Planning Commission Draft Motion

Hearing Date: November 10, 2011
Case No.: **2005.1004E**
Project Address: **Glen Park Community Plan Area**
Zoning: Various
Block/Lot: Various
Project Sponsor: San Francisco Planning Department
1650 Mission Street, Suite 400
San Francisco, CA 94103

TO: Members of the Planning Commission and Interested Parties
FROM: Bill Wycko, Environmental Review Officer
RE: **Attached Comments and Responses on Draft Environmental Impact Report, Case No. 2005.1004E Glen Park Community Plan Project**

Glen Park Community Plan

GLEN PARK COMMUNITY PLAN
FIGURE C&R-1: EXISTING ZONING IN GLEN PARK

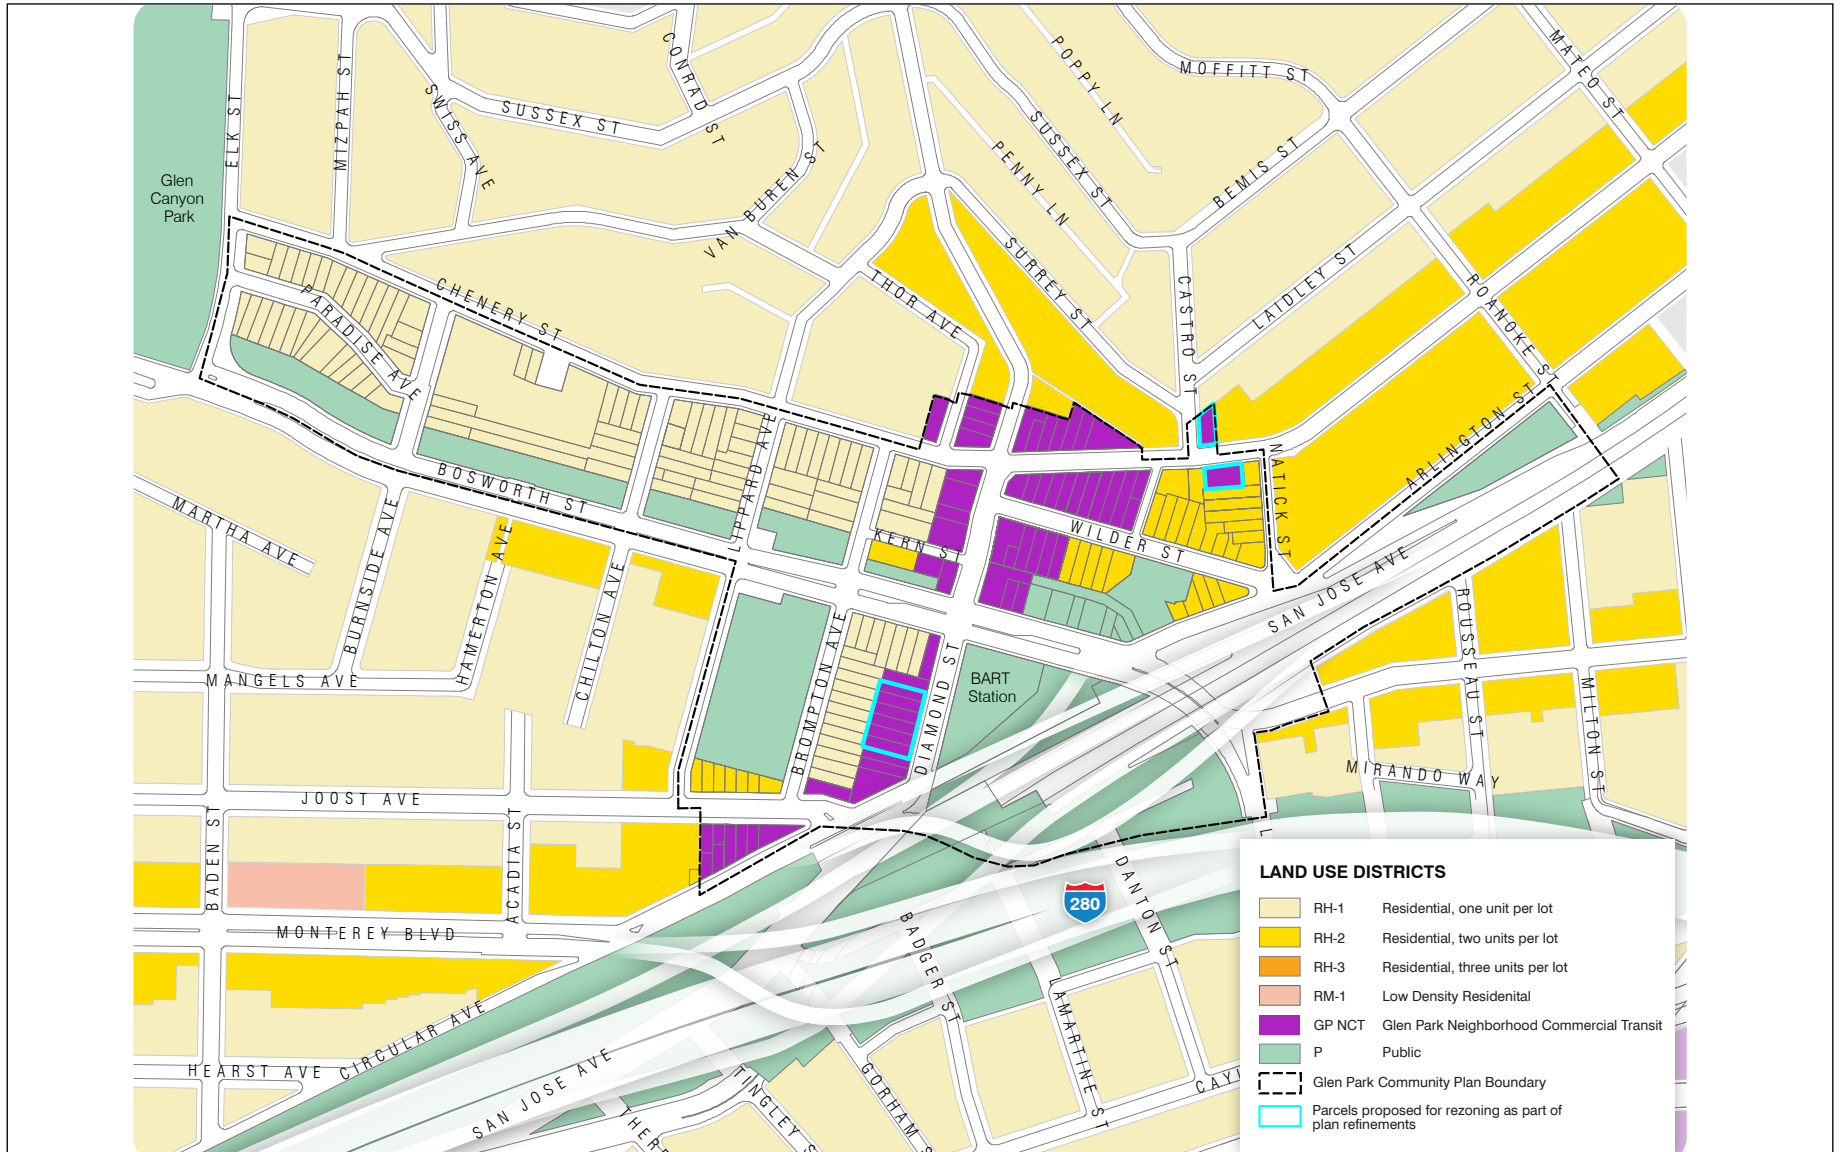
The plan refinements include rezoning six residential apartment buildings on the west side of Diamond Street (2928-2958), between Bosworth Street and Joost Avenue, from Residential House, Three Family (RH-3), as shown in Figure C&R-1, p. C&R-6, to Glen Park Neighborhood Commercial Transit (NCT), as shown in Figure C&R-2, p. C&R-7. As shown in the figures, the six parcels on Diamond Street are across the street from the Glen Park BART Station and are situated between mixed-use commercial and residential uses on either side. The current RH-3 zoning allows up to three dwelling units per 1,000 gross square feet (gsf) of lot area with a conditional use permit. The six parcels are currently occupied by three-story residential structures with ground-floor garages. Rezoning these six parcels to Glen Park NCT would be consistent with the rezoning of the parcels to the north and south along Diamond Street in Glen Park's commercial core already proposed as part of the *2010 Community Plan*.

GLEN PARK COMMUNITY PLAN
FIGURE C&R-2: PROPOSED ZONING UNDER THE 2010 COMMUNITY PLAN

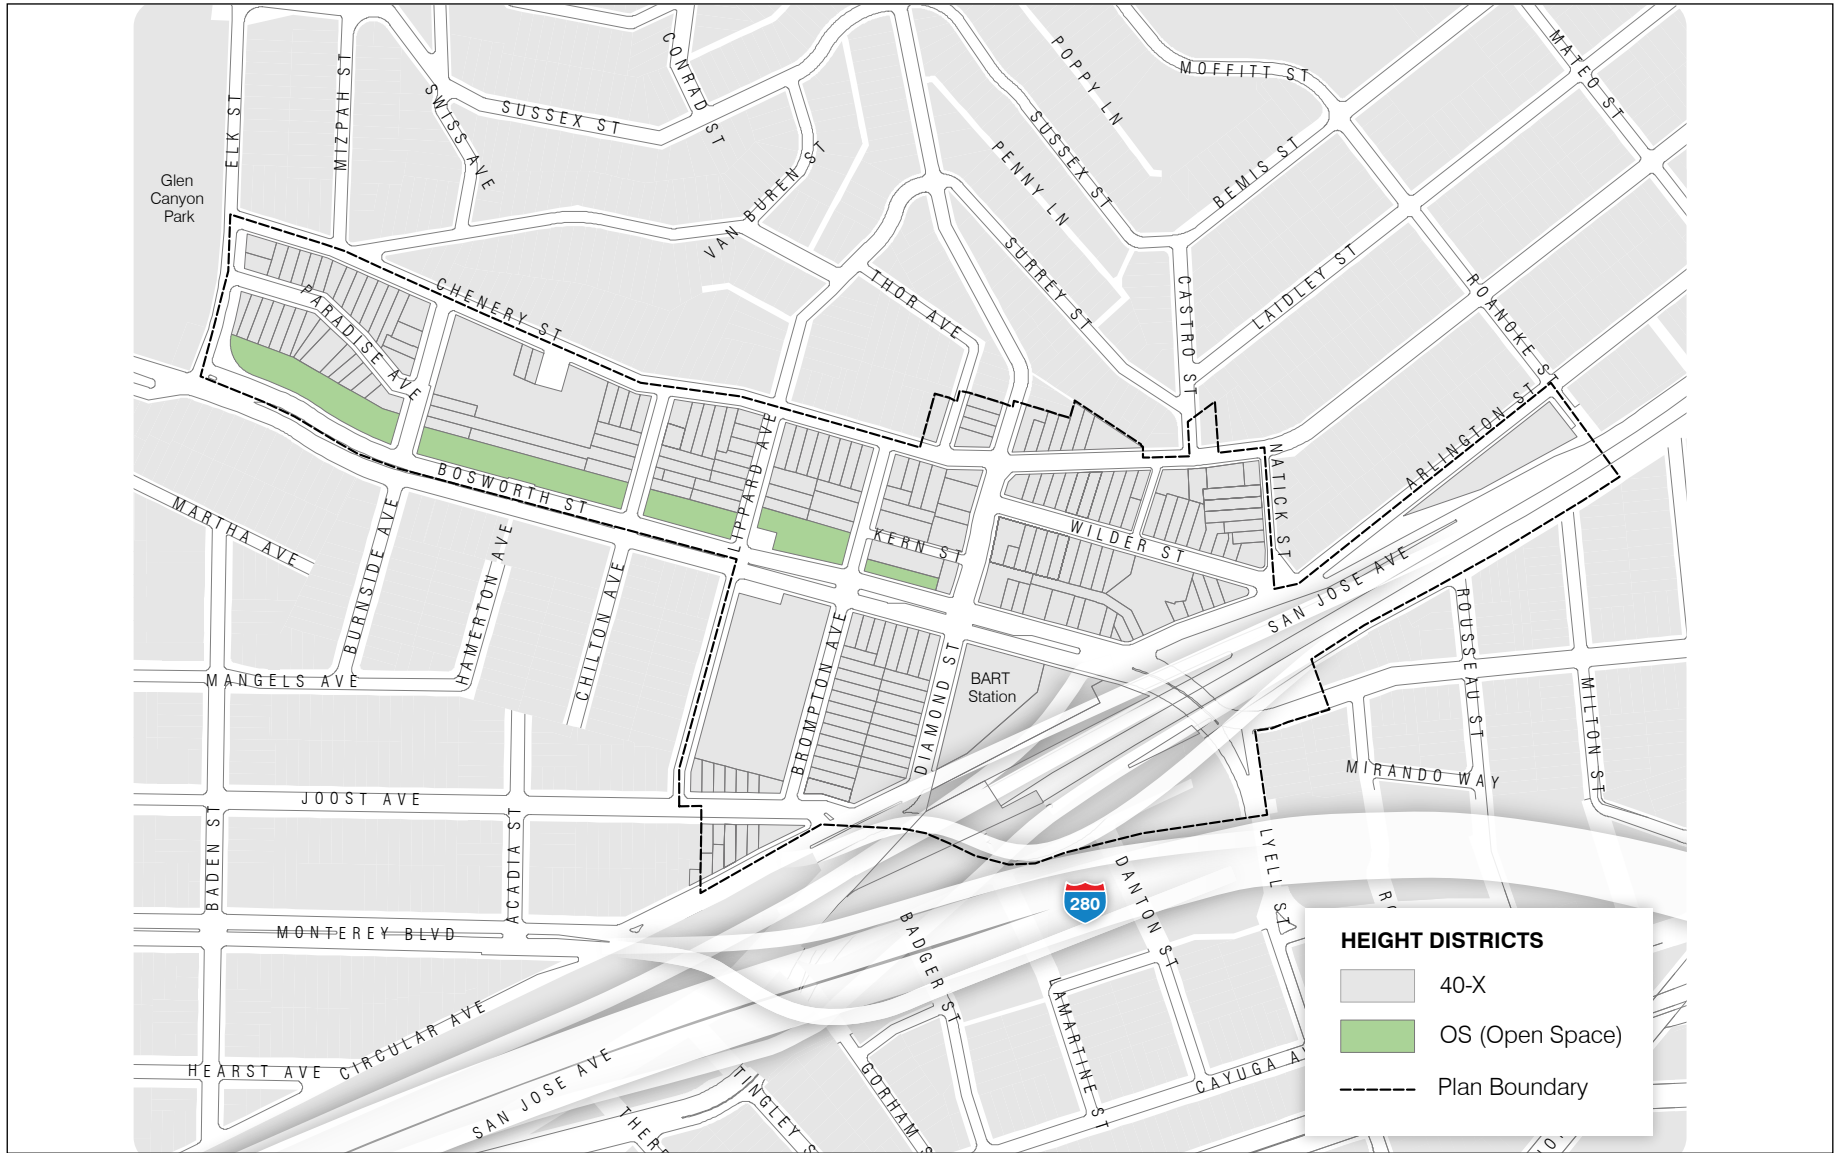
In addition to the properties on Diamond Street, the plan refinements include rezoning two residentially zoned properties, 605 Chenery Street and 3121-3125 Castro Street, from Residential House, Two Family (RH-2) to Glen Park NCT, as shown in Figure C&R-1 and Figure C&R-2, p. C&R-6 and C&R-7, respectively. The property at 3121-3125 Castro Street is not currently in the plan area and the *2010 Community Plan* area boundary would be adjusted to include this parcel, as shown in Figure C&R-1 and Figure C&R-2. The two parcels at 605 Chenery Street and 3121-3125 Castro Street are zoned residential, but are currently occupied by commercial uses. The building at 605 Chenery Street is one story and operates as a commercial use. The property at 3121-3125 Castro Street is occupied by a two-story mixed use building with a bakery on the ground floor and residential uses on the second floor. The current zoning designation, RH-2, allows up to two dwelling units per 1,500 gsf of lot area. Under the proposed Glen Park NCT zoning, these properties would be formally recognized as part of Glen Park's commercial district.

As noted above, the *2010 Community Plan* area boundary would be adjusted to include the property at 3121-3125 Castro Street. The fronting street and intersection would be included within the boundary adjustment, as show in Figure C&R-1 and Figure C&R-2, p. C&R-6 and C&R-7, respectively.

GLEN PARK COMMUNITY PLAN
FIGURE C&R-3: EXISTING HEIGHT LIMITS IN GLEN PARK

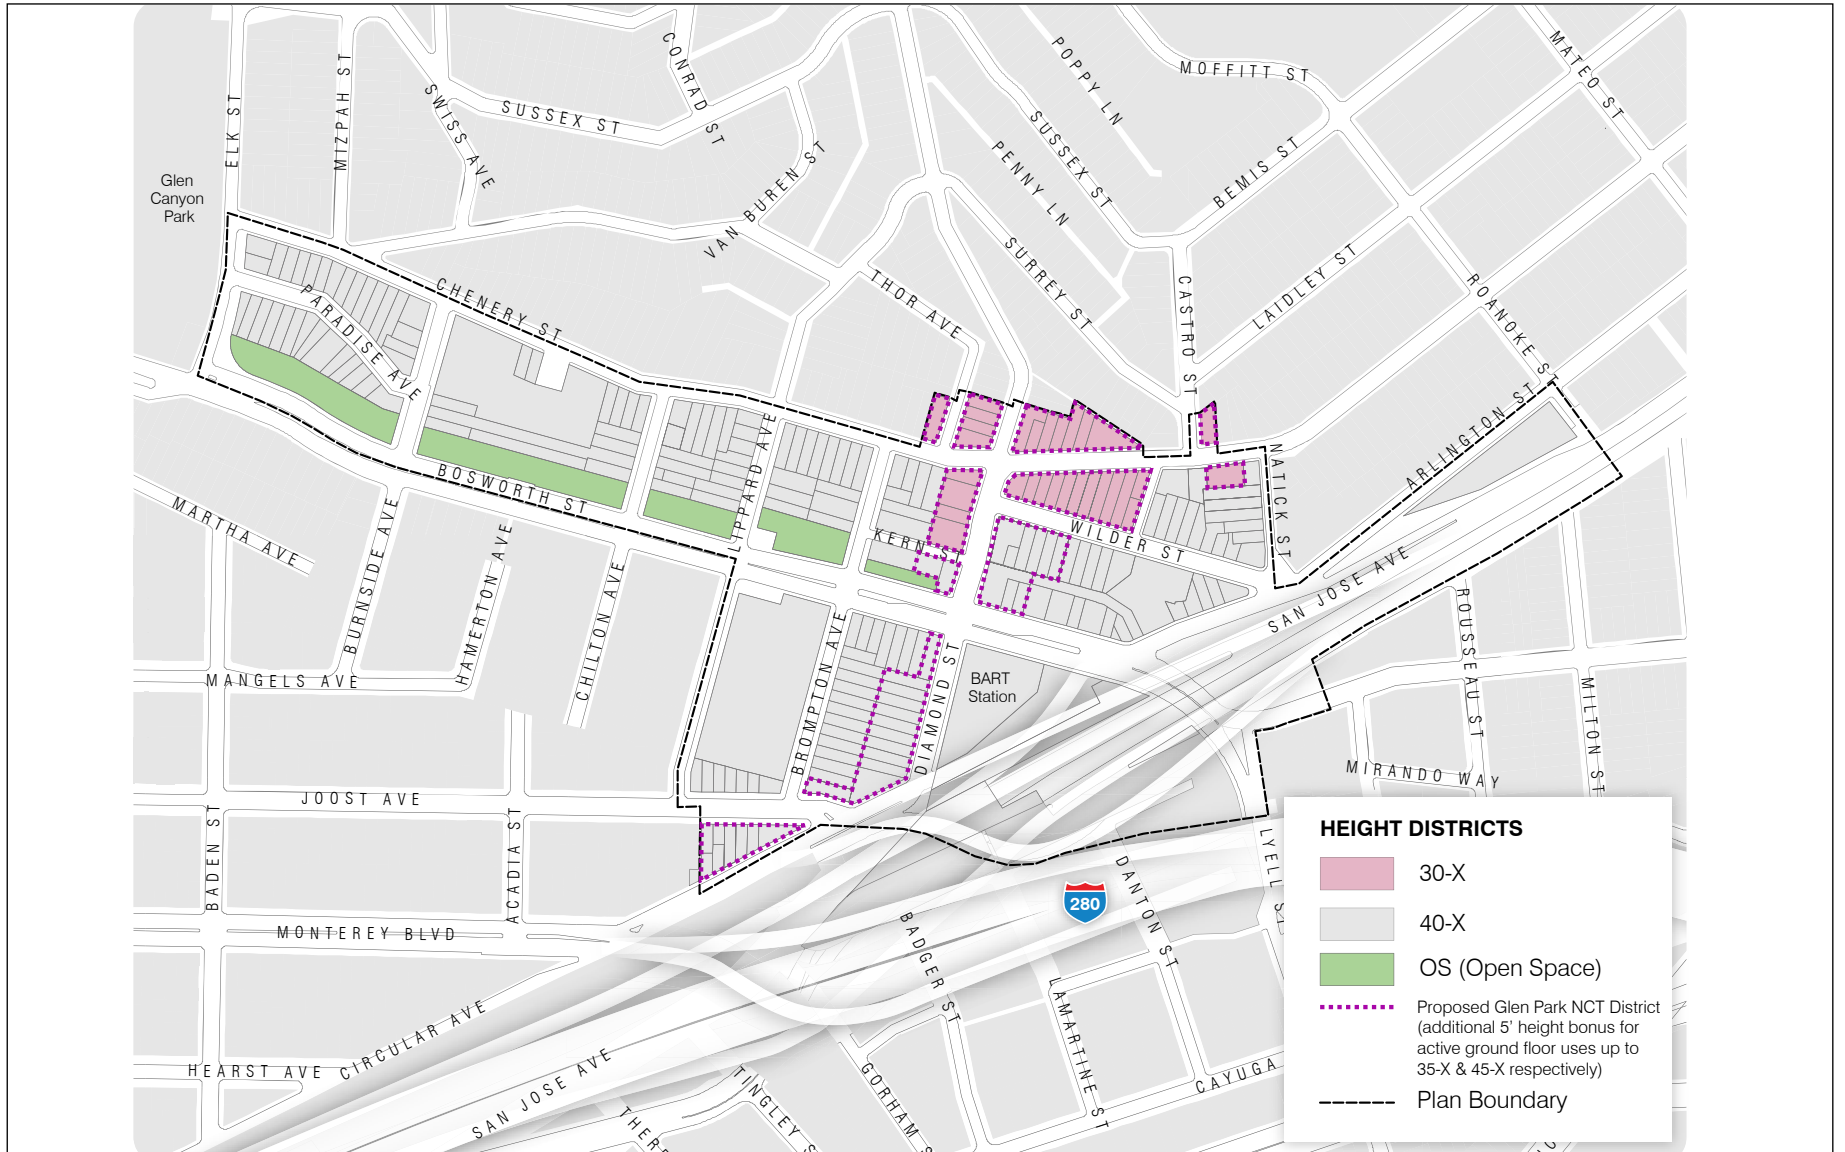
All height limits within the plan area are 40-X with the exception of the San Francisco Public Utilities Commission (SFPUC) easement, which is designated as an Open Space (OS) district (no limits apply), as shown in Figure C&R-3, p. C&R-9. As detailed in the DEIR, p. II-13, under the proposed Glen Park NCT zoning the height limit would be increased to 45 feet to encourage active ground-floor uses. However, the recommended height district refinement includes reducing the maximum height of new construction along portions of Wilder Street, Diamond Street, Castro Street, and Chenery Street in the Glen Park NCT District from a range of 40 to 45 feet to a range of 30 to 35 feet, as shown in Figure C&R-4, p. C&R-10.

GLEN PARK COMMUNITY PLAN
FIGURE C&R-5 (REVISED FIGURE II-1): REGIONAL AND CITY PROJECT LOCATION

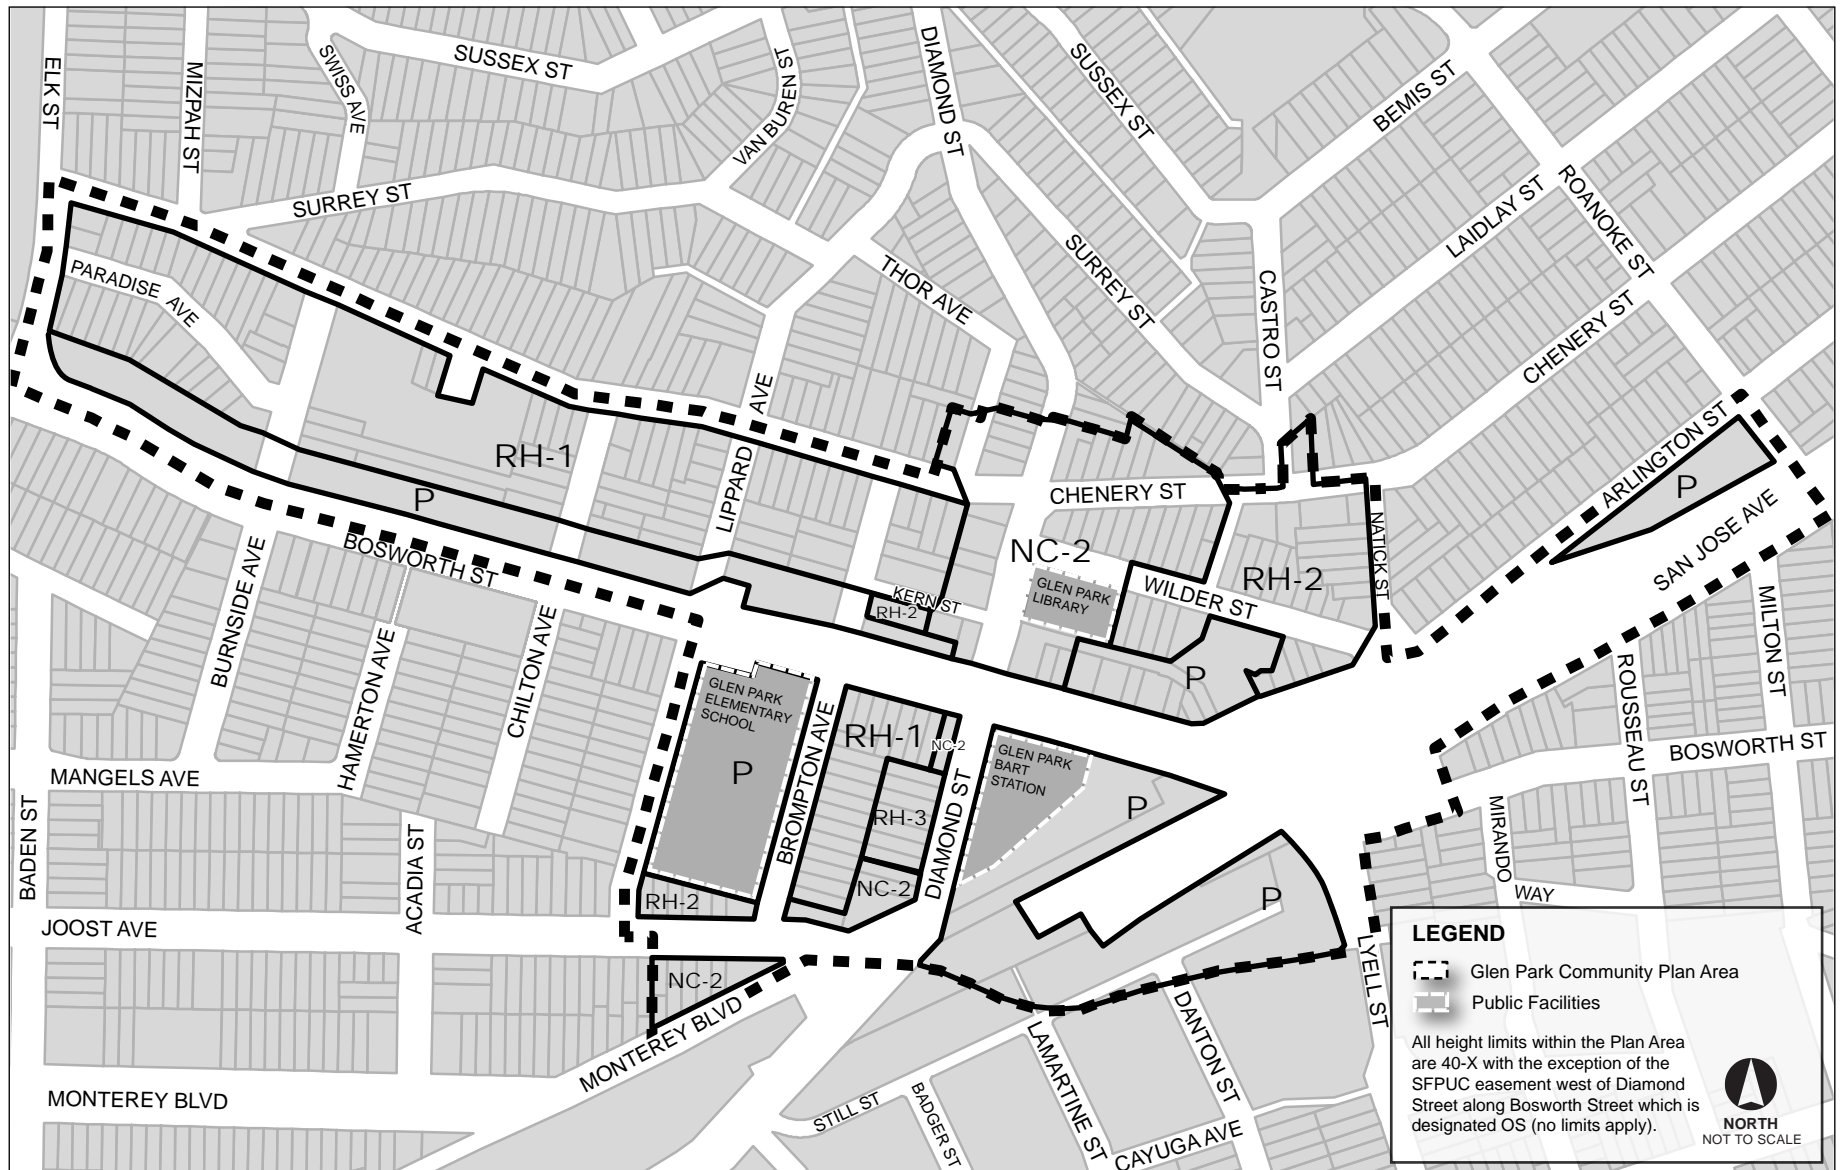
Nine figures have been revised to update the plan area boundary to include 3121-3125 Castro Street and the fronting street and intersection. These figures include:

- Figure II-1, p. II-7, Regional and City Project Location
- Figure II-2, p. II-10, Existing Use Districts and Height Limits
- Figure II-3, p. II-14, Use Districts and Height Limits Under the Proposed Project
- Figure II-4, p. II-23, Transportation Improvement Locations
- Figure III.B-1, p. III.B-16, Cumulative Projects for Glen Park Community Plan
- Figure III.D-1, p. III.D-13, Existing Historical Resources with the Plan Area
- Figure III.E-2, p. III.E-10, Existing Transit Network
- Figure III.E-3, p. III.E-19, Existing Bicycle Conditions
- Figure III.F-1, p. III.F-8, Noise Monitoring Locations
